工程指示 / 要求簡箋 ENGINEER INSTRUCTIONS(E.I.)

工程指示編號:	EI- 4570	修改版本:	-
	HK- 591		
工程編號:	J 852	工程名稱:	亞皆老街中電
收件人:	生統	發件人:	Eric Liu
工程項目:	佛沙及後裝窗 後加滴水線(T1-T3)	日期:	08/04/2022

模號: 4x10mmU槽
 名稱: 隔音板用U槽
 合金狀態: 6063-T5
 重量: 0.048 KG/M
 V.F.: 0 mm

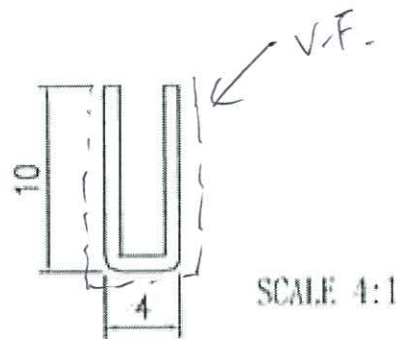
內容: 請按加工圖及資料開料生產後加滴水線送地盤安裝
 (已包後裝+佛沙窗, 只做side hung窗玉位置, 梗窗及top hung窗玉不需要安裝)
 因現時窗玉關窗後, 滴水線出入數後於窗玉, 不能達至滴水線功能
 按業主要求, 現需加U槽作後加滴水線
 出貨包裝, 請分座分層及分單位, 直接打紮, 現場派料
 需有顏色: UCT806812XL-3
 共需總長907m, 謝謝

料號 = UCT 806812XL-3

總料長 = 907 m

按 5.2米一支

支需 175支
